KIRKSVILLE REGIONAL AIRPORT KIRKSVILLE, MISSOURI MODOT PROJECT NO. 24-028A-1

ADDENDUM NO. 3 TO

CONTRACT DOCUMENTS, SPECIFICATIONS AND PLANS FOR IMPROVEMENTS TO THE KIRKSVILLE REGIONAL AIRPORT KIRKSVILLE, MISSOURI MODOT PROJECT NO. 24-028A-1

SHEET NAME:
MARKING PLAN

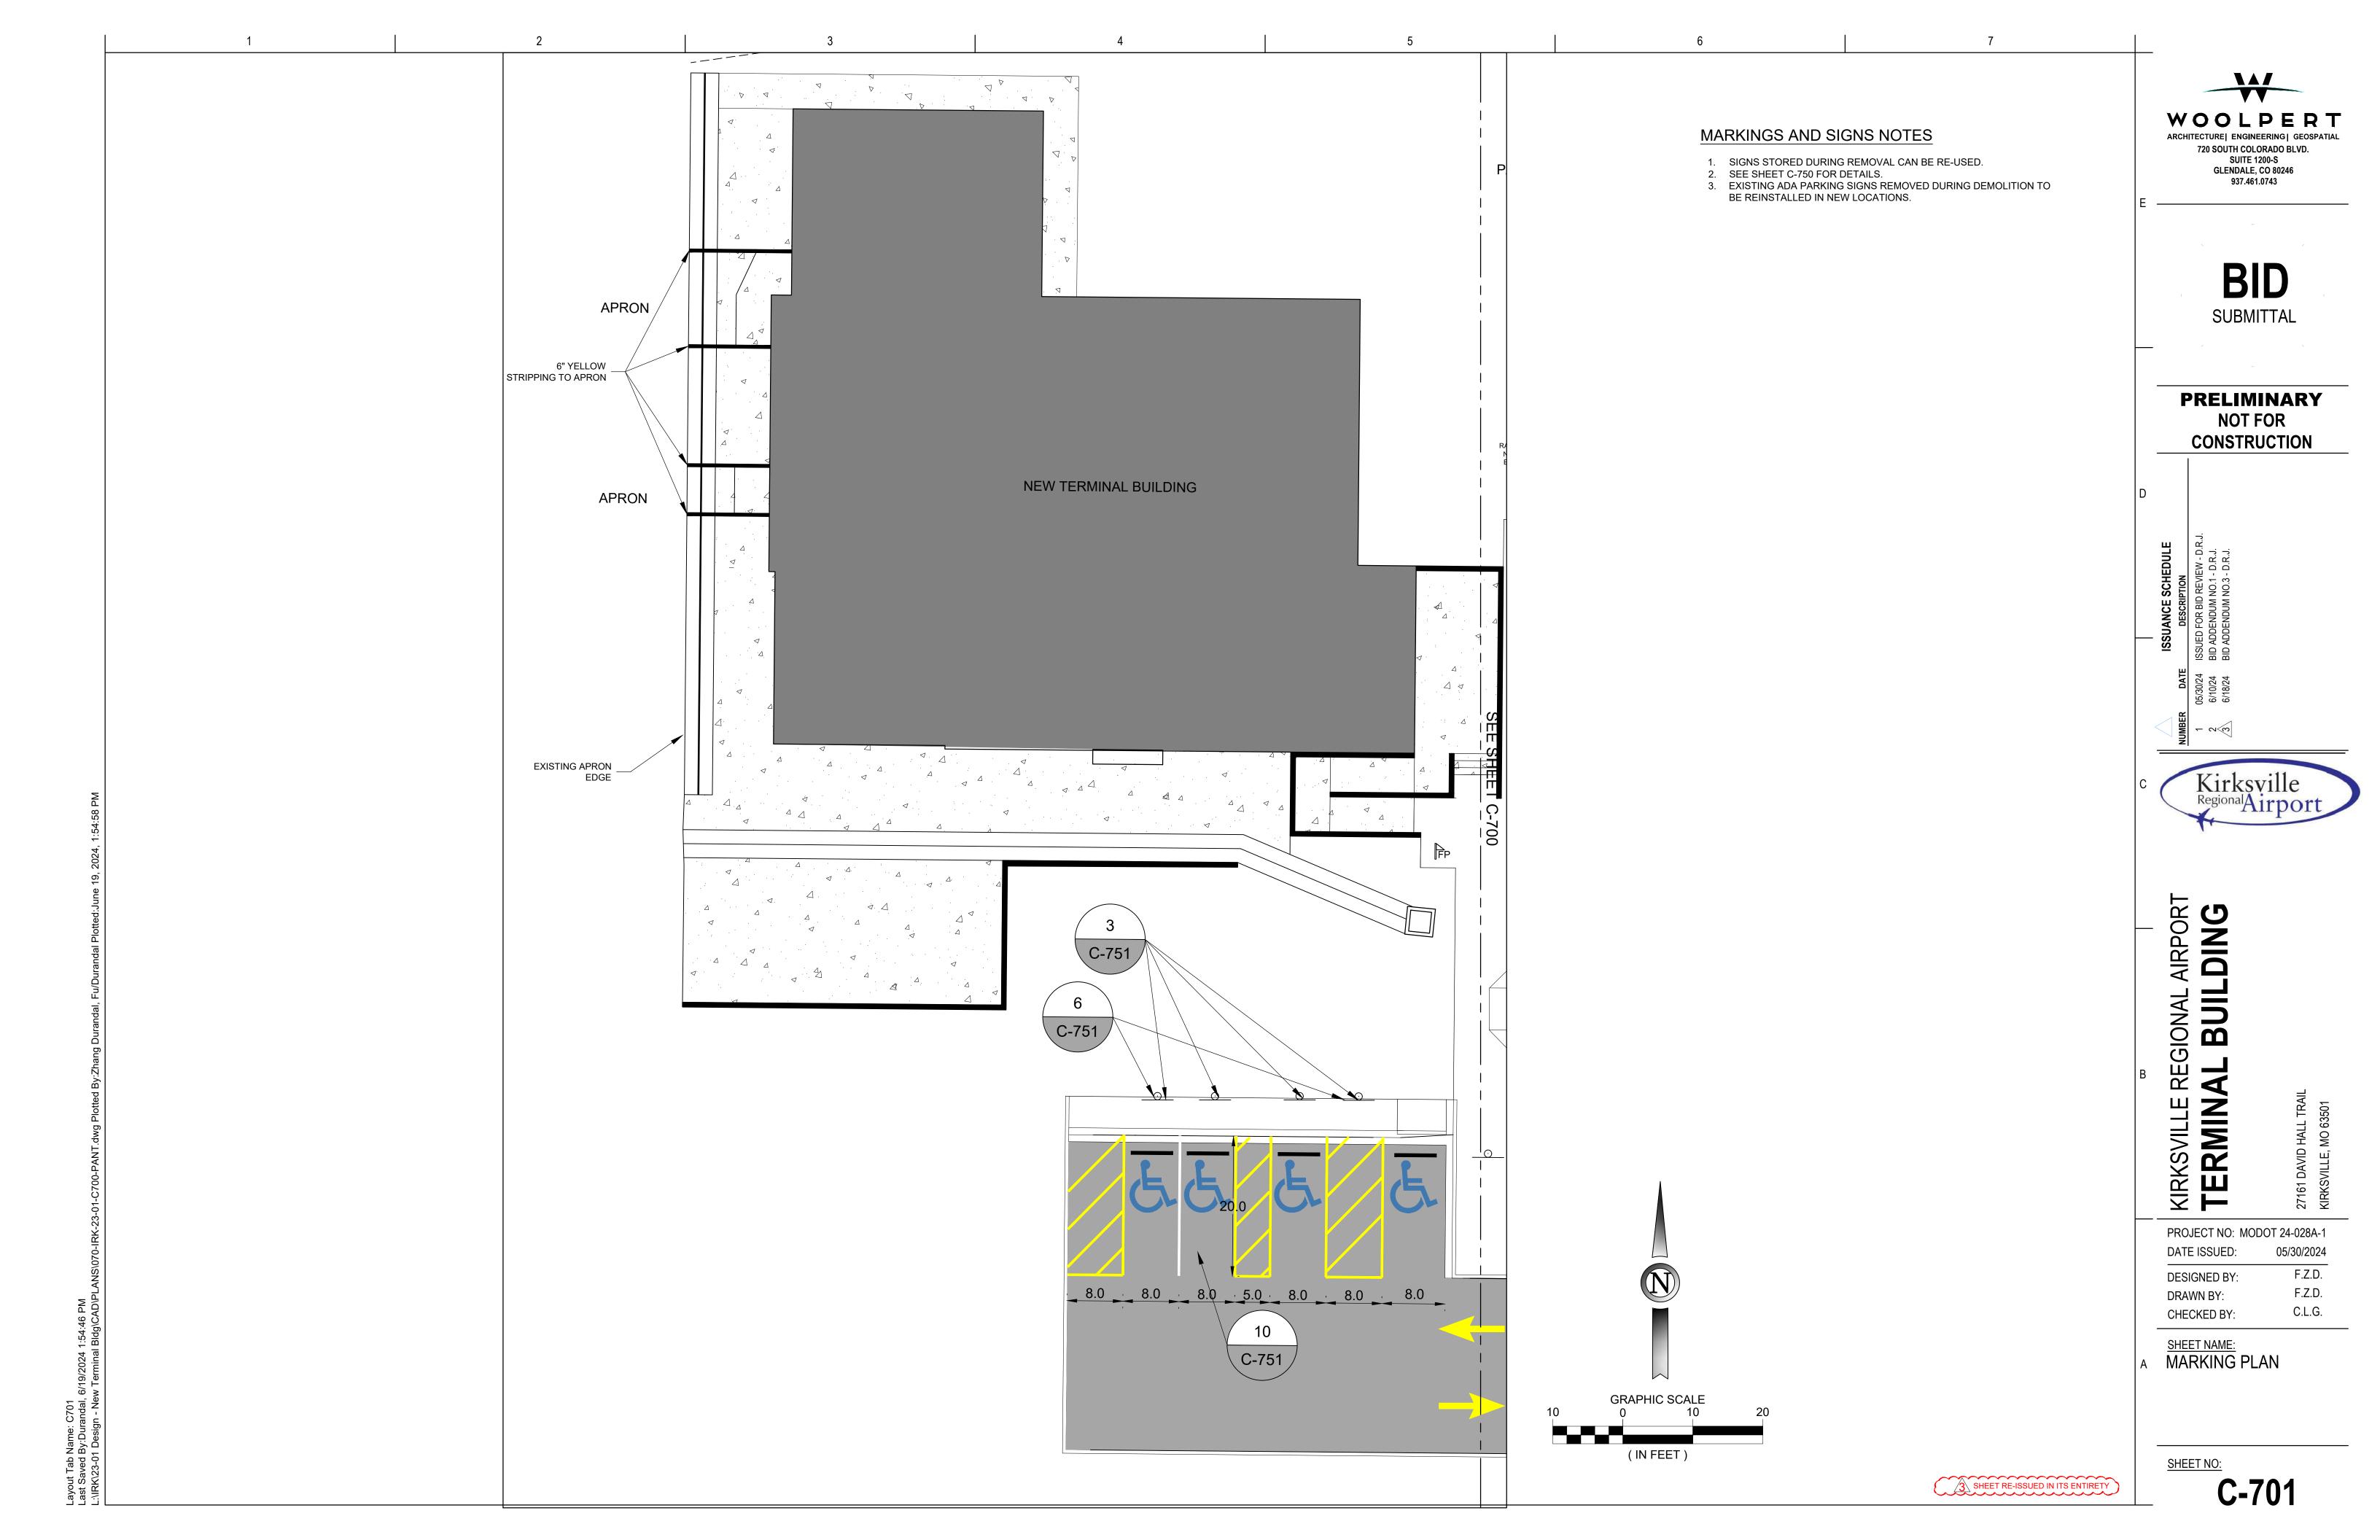
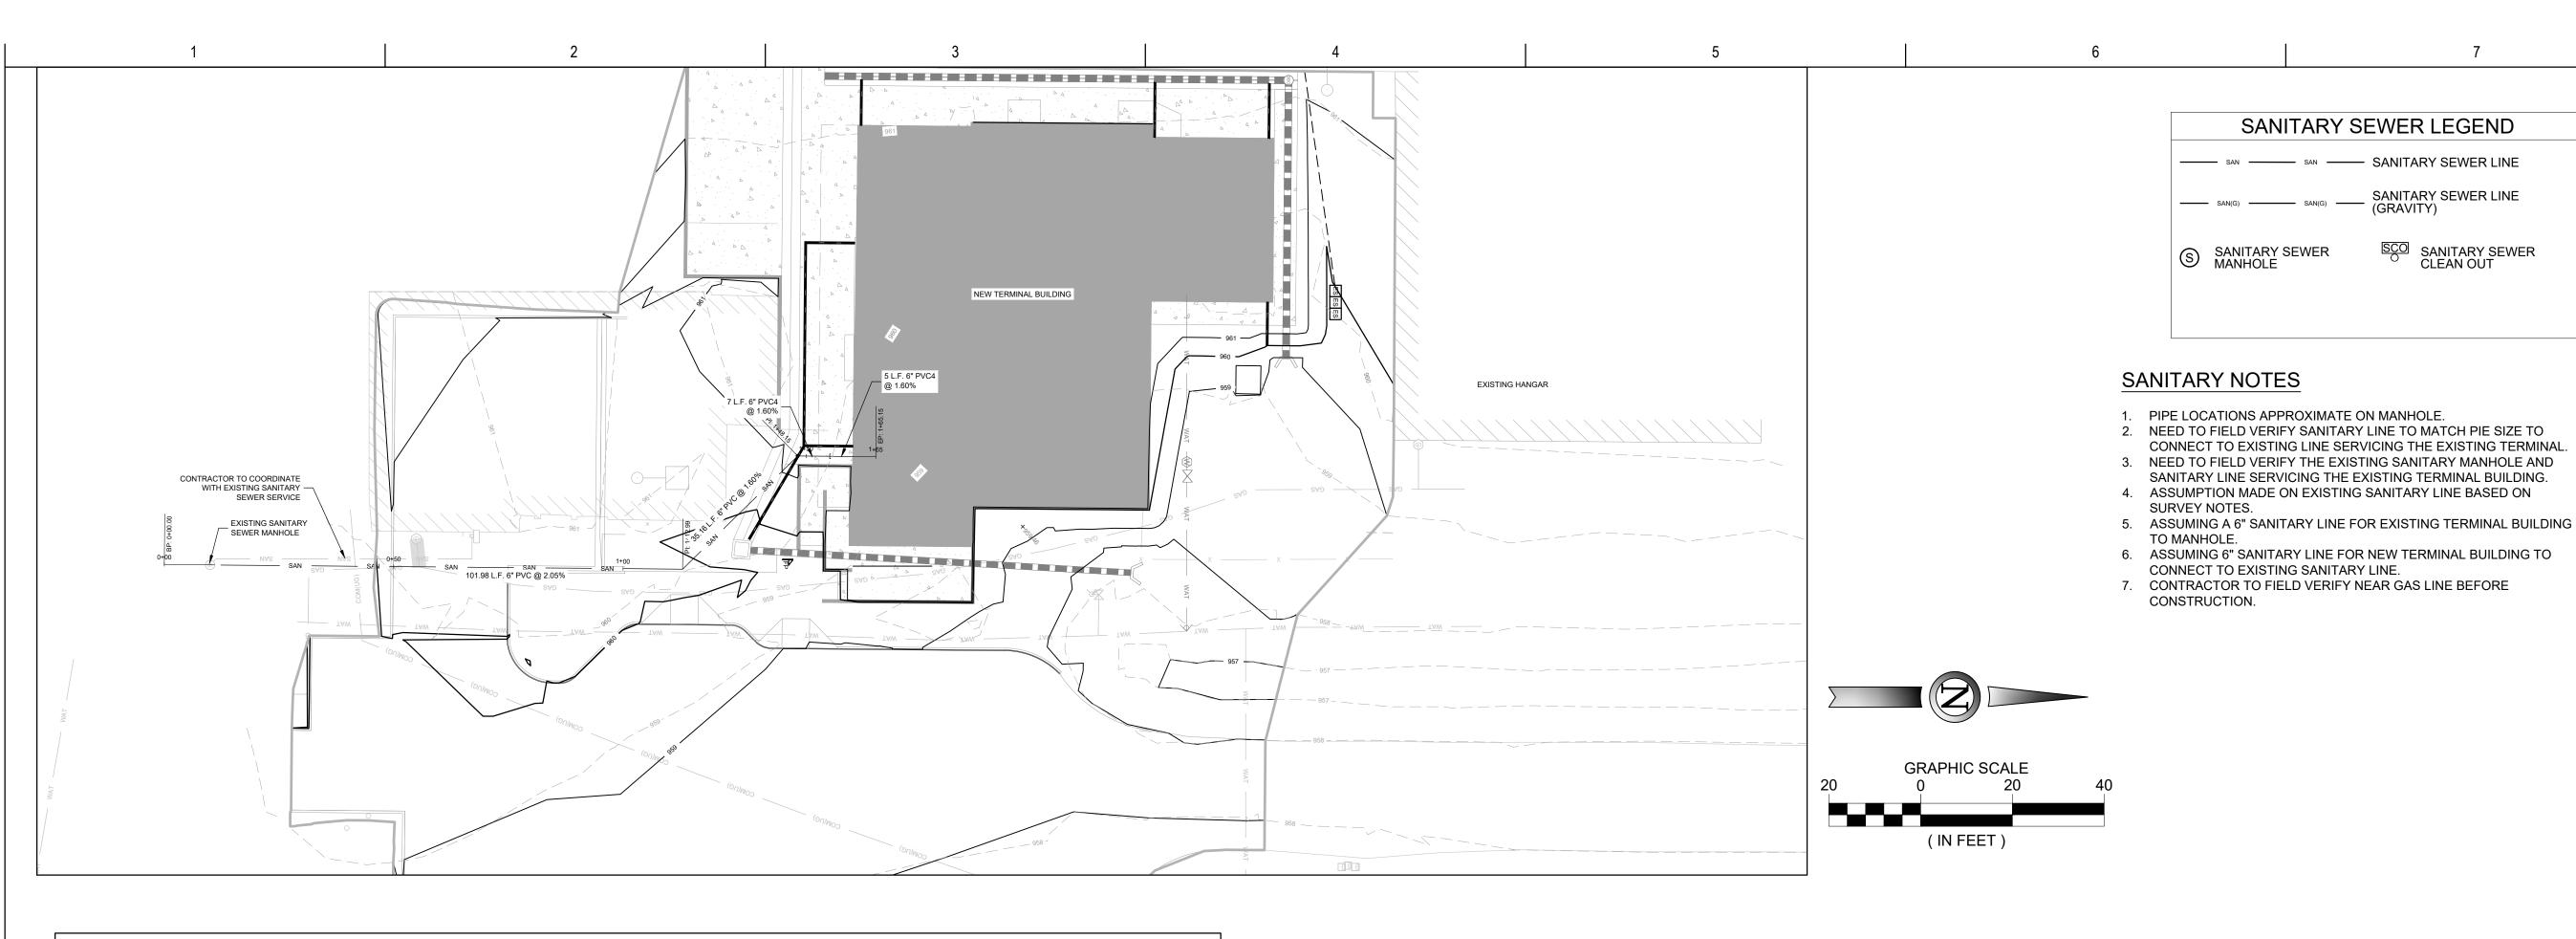
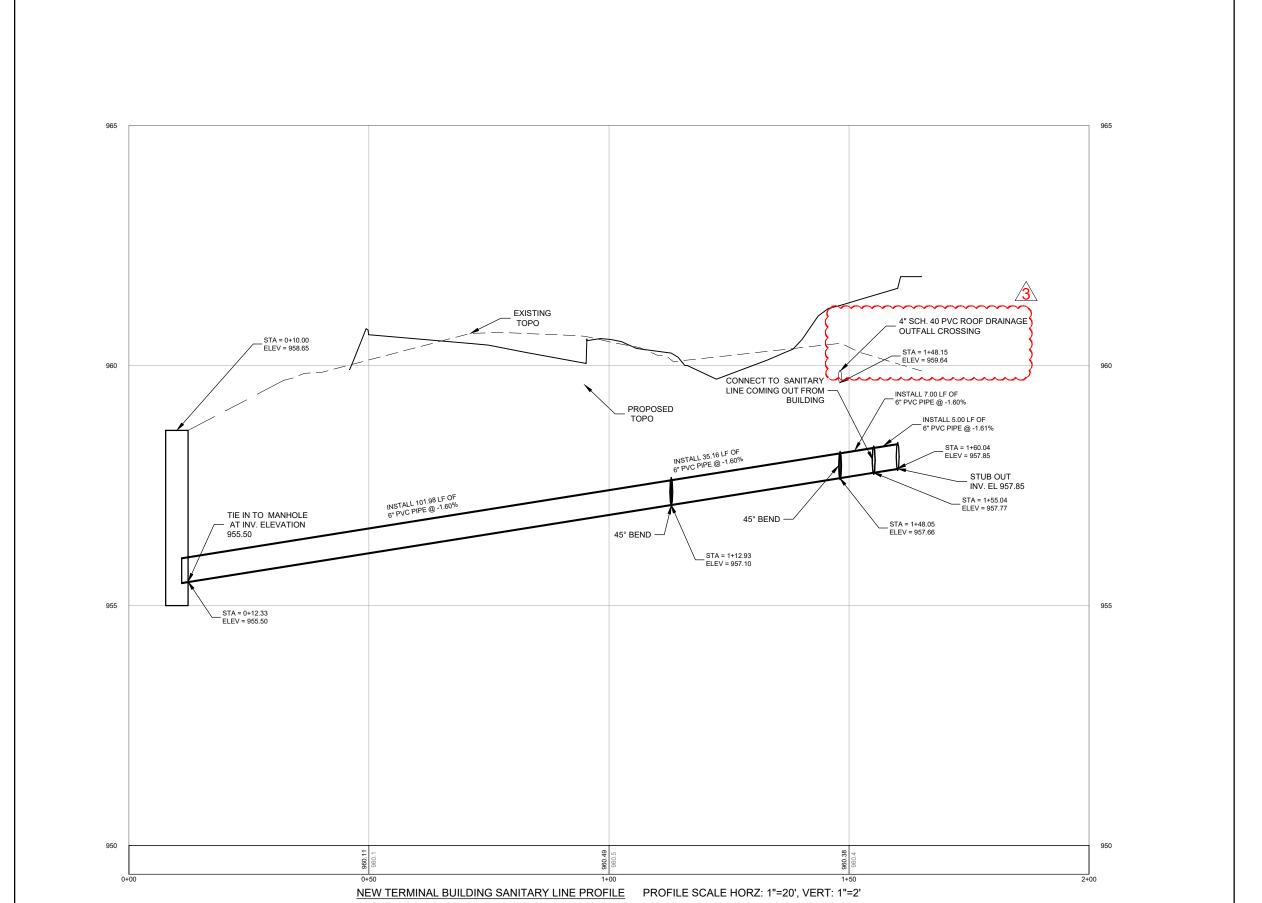
Revision: Parking lot geometry and marking revised. Angled parking changed from 60 degrees to 45

degrees. Striping added to ADA passenger dropoff.
